ADDENDUM NO. 2

**Federal Aid Project No. NHP-002S(539)
Bridge Replacement Br. No. C-07-001 (Single Leaf Bascule) Bridge Street
over the Mitchell River (ABP)**

CHATHAM
Federal Aid Project No. NHP-002S(539)
Bridge Replacement Br. No. C-07-001 (Single Leaf Bascule)
Bridge Street over the Mitchell River (ABP)

RESPONSE TO BIDDER QUESTION

**BASCULE LEAF
COUNTERWEIGHT
BALLAST DETAILS
1 OF 2**

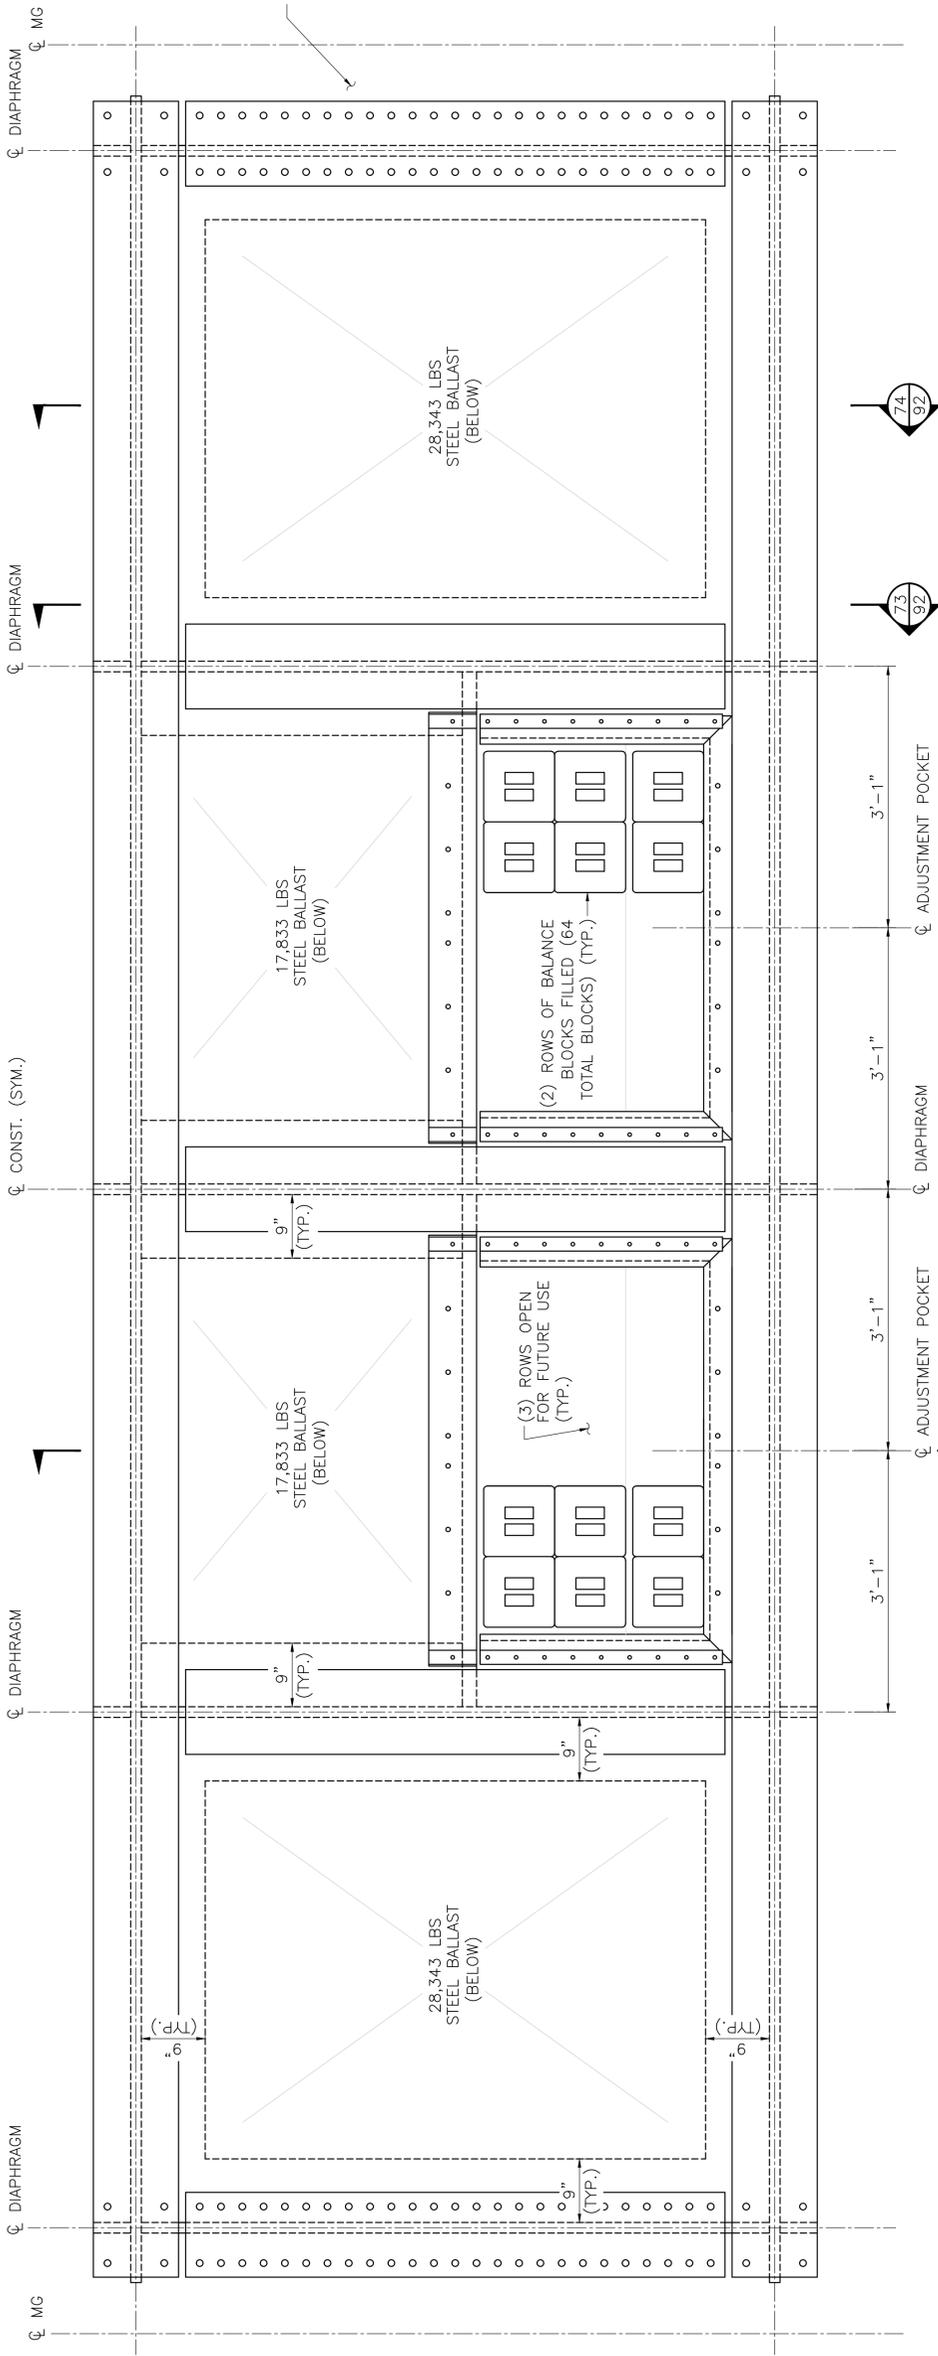
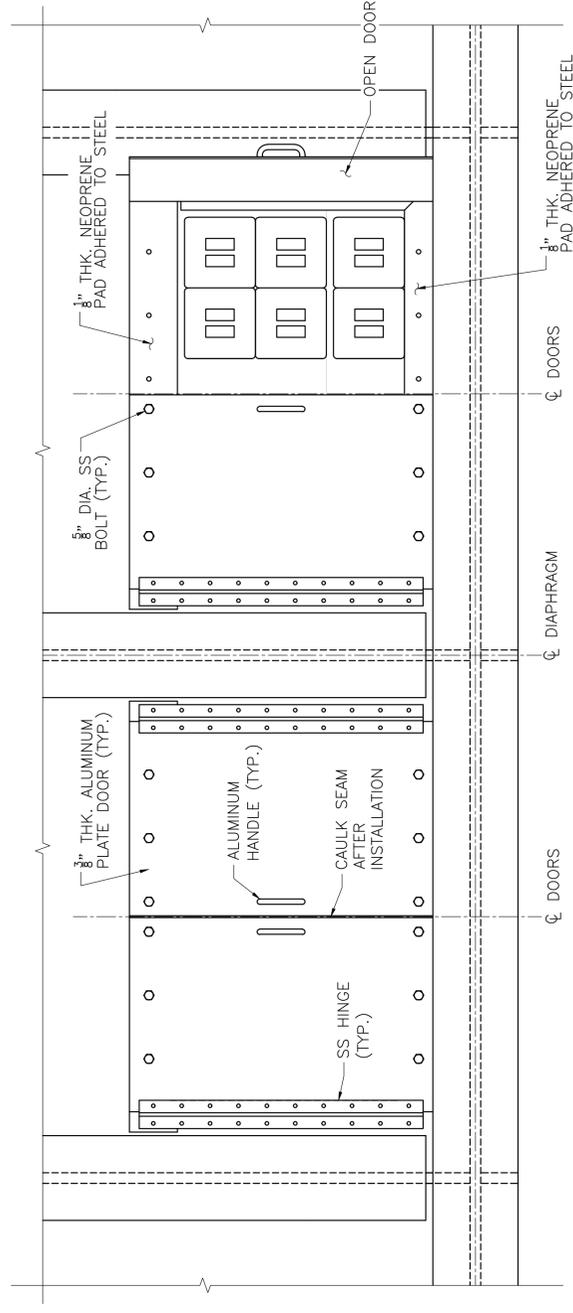
Question No. 6 (i) [Question regarding Design Sheet 126 of 173]:

Section 104 and Section 105 indicate the direction of rolling of trunnion plates running the length of the trunnion girder.

Question No. 6 (ii) [Question regarding Design Sheet 126 of 173]:

Normally direction of rolling is perpendicular to the direction of bend.

Question No. 6 (iii) [Question regarding Design Sheet 126 of 173]:

Plate rolling suppliers are indicating that likelihood of plate cracking is great with bending in the same direction of rolling

Question No. 6 (iv) [Question regarding Design Sheet 126 of 173]:
Please verify if plans are correct.

Question No. 6 (v) [Question regarding Design Sheet 126 of 173]:
If direction of rolling is changed as noted in item #2 above, will a butt weld be allowed in the length of the center trunnion girder since 1" plate cannot be purchased 20' wide?

Response No. 6(iv):
The direction of rolling for the 1" plate used to fabricate the trunnion girder tubes should be in the circumferential direction and not along the axis of the tube. .

Response No. 6(v):
A complete joint penetration butt welded splice will be permitted at the center of the tube.

NOTES:
1. COUNTERWEIGHT BALLAST CONCRETE SHALL BE 4000 PSI, 3/4 IN., 585 HP CEMENT CONCRETE.

FEB. 28, 2014	ADDED NOTE 1 - ADDENDUM 2
OCT. 26, 2013	ISSUED FOR CONSTRUCTION
DATE	DESCRIPTION
USE ONLY PRINTS OF LATEST DATE

RESISTANCE GATE DETAILS 2 OF 2

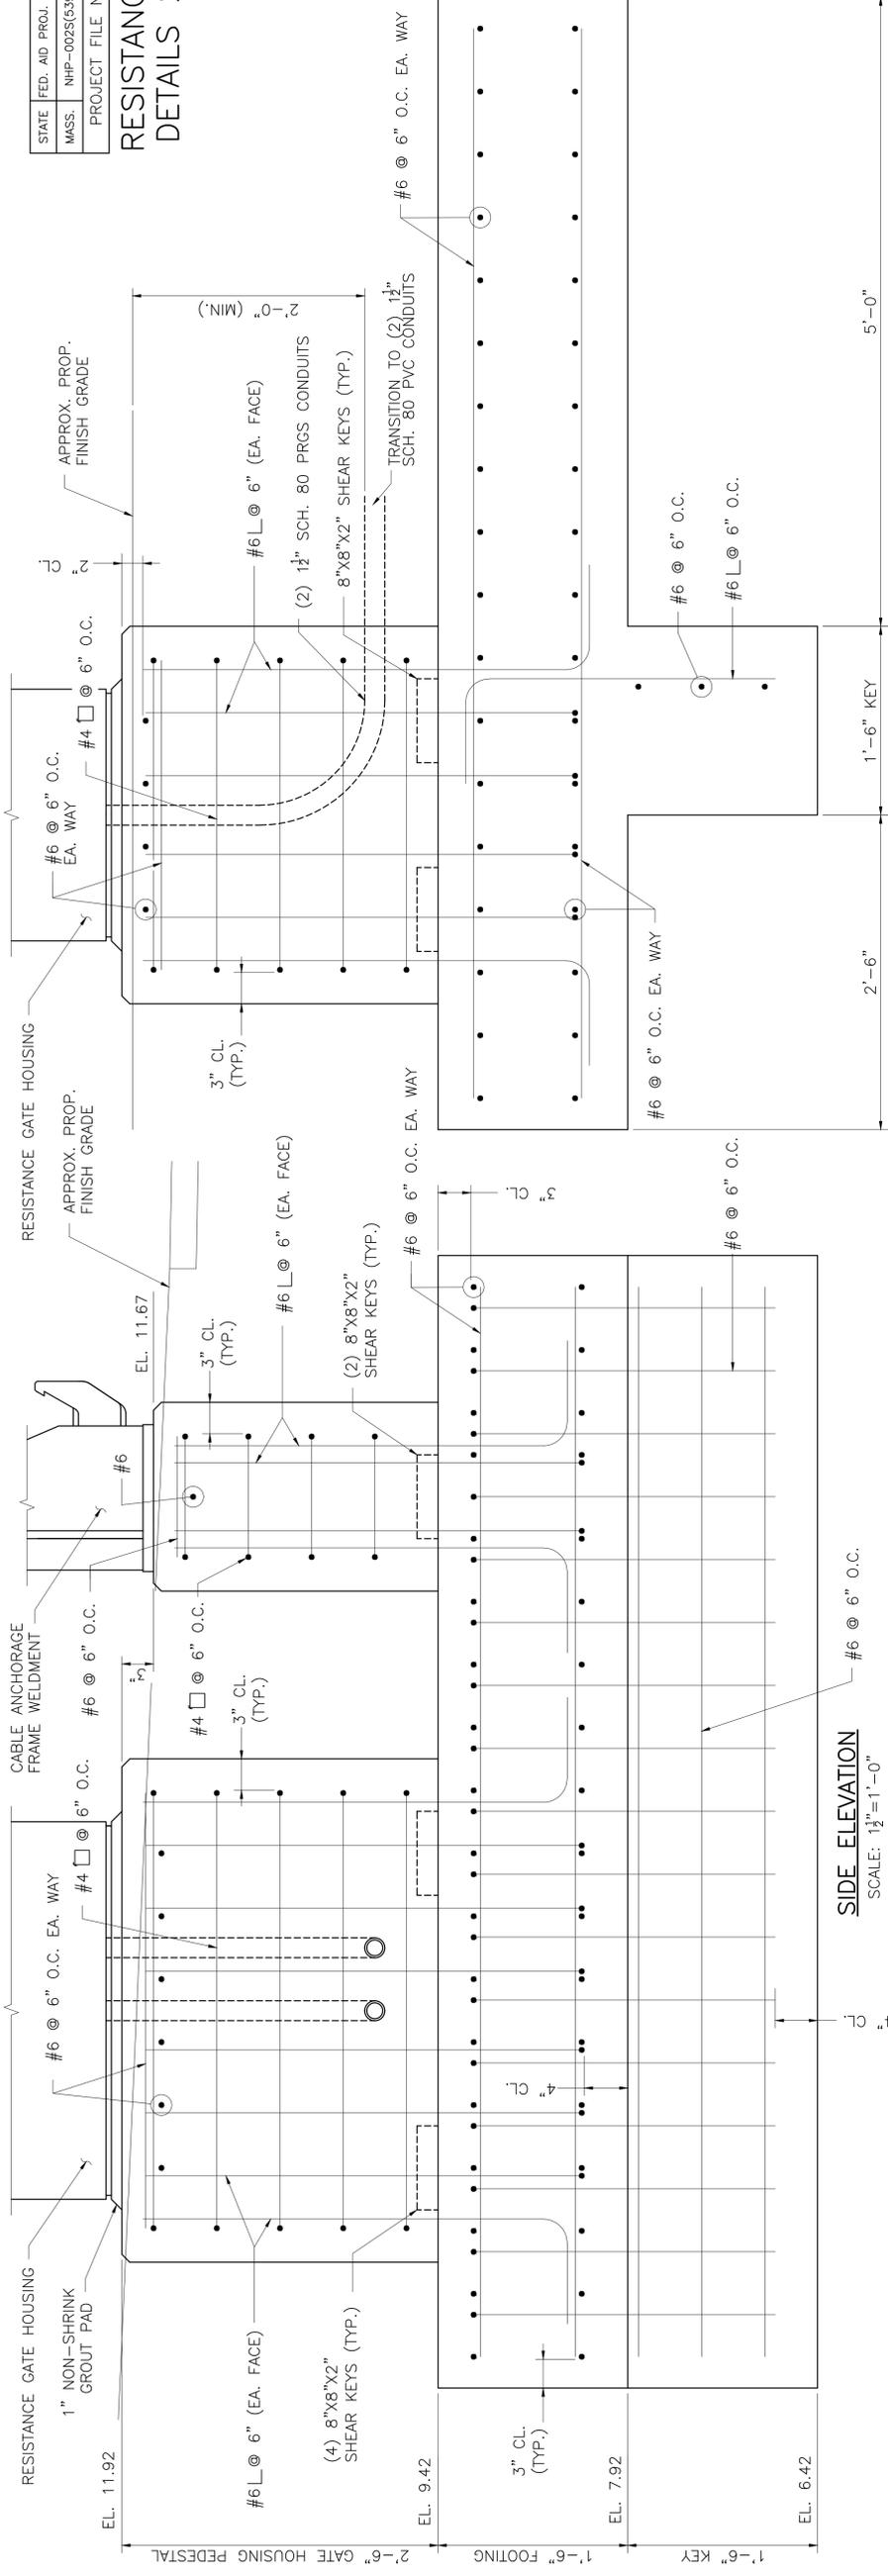
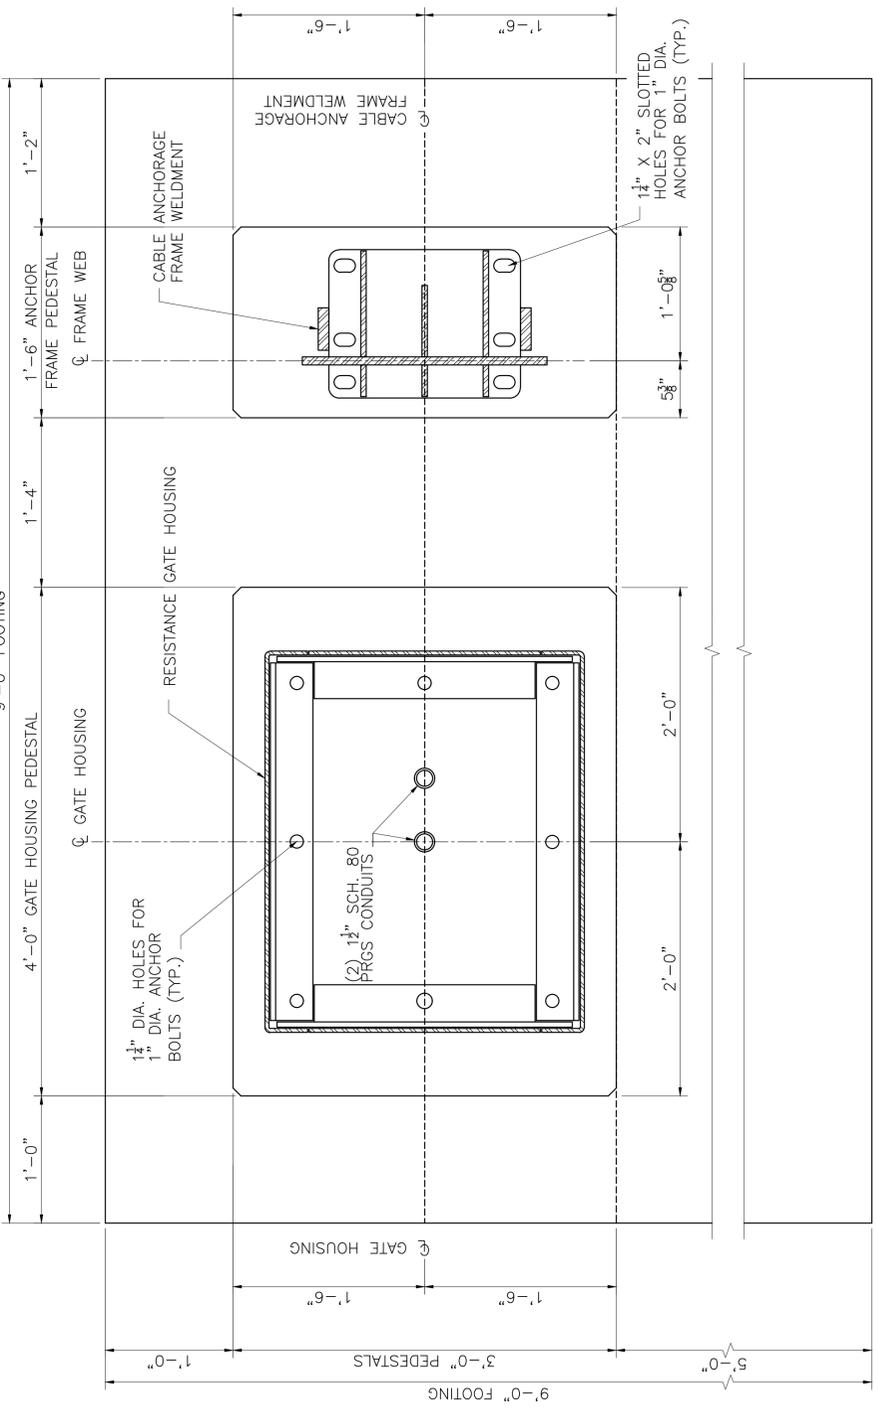
FEB. 28, 2014	REVISED NOTE 1 - ADDENDUM 2
OCT. 26, 2013	ISSUED FOR CONSTRUCTION
DATE	DESCRIPTION
	USE ONLY PRINTS OF LATEST DATE

- ALL CONCRETE SHALL BE 4000 PSI, 4 IN. 585 HP CEMENT CONCRETE.
FACTORED BEARING PRESSURE = 1.1 KSF PER AASHTO LRFD BRIDGE DESIGN SPECIFICATIONS EXTREME EVENT II LOAD COMBINATION.
- FACTORED BEARING RESISTANCE = 6.8 KSF. FACTORED BEARING RESISTANCE IS THE PRODUCT OF NOMINAL BEARING RESISTANCE AND RESISTANCE FACTOR OF 0.45.
- FACTORED LATERAL LOAD = 33 KIPS PER AASHTO LRFD BRIDGE DESIGN SPECIFICATIONS EXTREME EVENT II LOAD COMBINATION.
- FACTORED LATERAL RESISTANCE = 34.7 KIPS. FACTORED LATERAL RESISTANCE IS THE SUM OF:
 - PRODUCT OF THE NOMINAL SLIDING RESISTANCE AND RESISTANCE FACTOR OF 0.80 = 18.0 KIPS
 - PRODUCT OF THE NOMINAL PASSIVE BEARING RESISTANCE AND RESISTANCE FACTOR OF 0.50 = 16.7 KIPS
- ANCHOR BOLTS SHALL BE AS RECOMMENDED BY THE RESISTANCE GATE MANUFACTURER.
- ALL KEYS TO BE SLIGHTLY TAPERED.
- FOR RESISTANCE GATE LAYOUT DRAWINGS SEE SHEET 171.
